Access Compliance Report

Public Rights-of-Way

Intersection ID: 43656	Main Street: HUNTINGTON_MEADOW_LN	Cross Street: CALLOW_FOREST_DR	Location: NE
ADA ID: 2E72D9EED145	Ramp Type: BlendTrans2	Initial Pass/Fail: Fail	Overall Compliance: No
Severity Score: 8.75			
Codes/Mitigation Info/Possible Solution		Field Measurements/Component Compliance

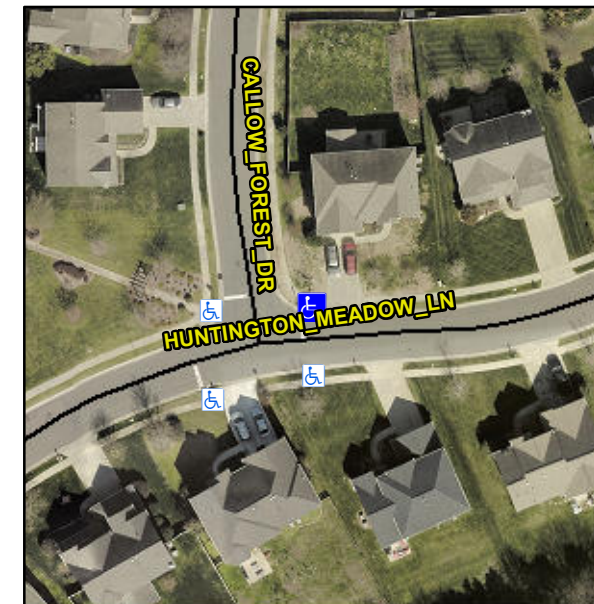
Not Found, R304.5.1

Compliance	Description	Data	Compliance	Description	Data
N/A	Ramp Length (in)	94.0	Yes	BlendTrans Slope (%)	4.4
No	Ramp Width (in)	39.5	Yes	BlendTrans XSlope (%)	2.0
N/A	Flare Type LT	N/A	N/A	Flare Type RT	N/A
N/A	Flare Slope LT (%)	N/A	N/A	Flare Slope RT (%)	N/A
N/A	Flare Traversable LT?	N/A	N/A	Flare Traversable RT?	N/A
N/A	Landing Length (in)	N/A	N/A	DWS Provided?	N/A
N/A	Landing Width (in)	N/A	N/A	DWS Contrast?	N/A
N/A	Landing Slope (%)	N/A	N/A	DWS Length (in)	N/A
N/A	Landing X Slope (%)	N/A	N/A	DWS Full Width?	N/A
N/A	Landing Curb? (Y/N)	N/A	N/A	DWS Offset (in)	N/A
N/A	Shared Landing?	N/A			
N/A	Gutter Ponding?	N/A	N/A	Gutter Slope (%)	N/A
N/A	Gutter Lip Ht (in)	N/A	N/A	Gutter X Slope (%)	N/A
N/A	Painted X Walk1?	No	N/A	Painted X Walk2?	No
	X Walk 1 Direction	To W		X Walk 2 Direction	To S
	X Walk 1 Width (in)	N/A		X Walk 2 Width (in)	N/A
	X Walk 1 Slope (%)	0.7		X Walk 2 Slope (%)	2.4
	X Walk 1 X Slope (%)	4.1		X Walk 2 X Slope (%)	2.1

N/A	Ramp inside XWalk1?	N/A	N/A	Ramp inside XWalk2?	N/A
	Road Slope (%)	0.8		Clear Space?	N/A
	Road X Slope (%)	1.1	N/A	Clear Space to XWalk (in)	N/A
N/A	Any Obstructions?	N/A	N/A	Storm Grate/Utility Hazard?	N/A
	Obstruction Type			Storm Grate/Utility Type	
		N/A			N/A
			Yes	Surface Condition? (G/P)	Good
			No	Curb Slope (%)	16.7

Remove & Replace Curb Ramp With Two New Directional Ramps or Equivalent.
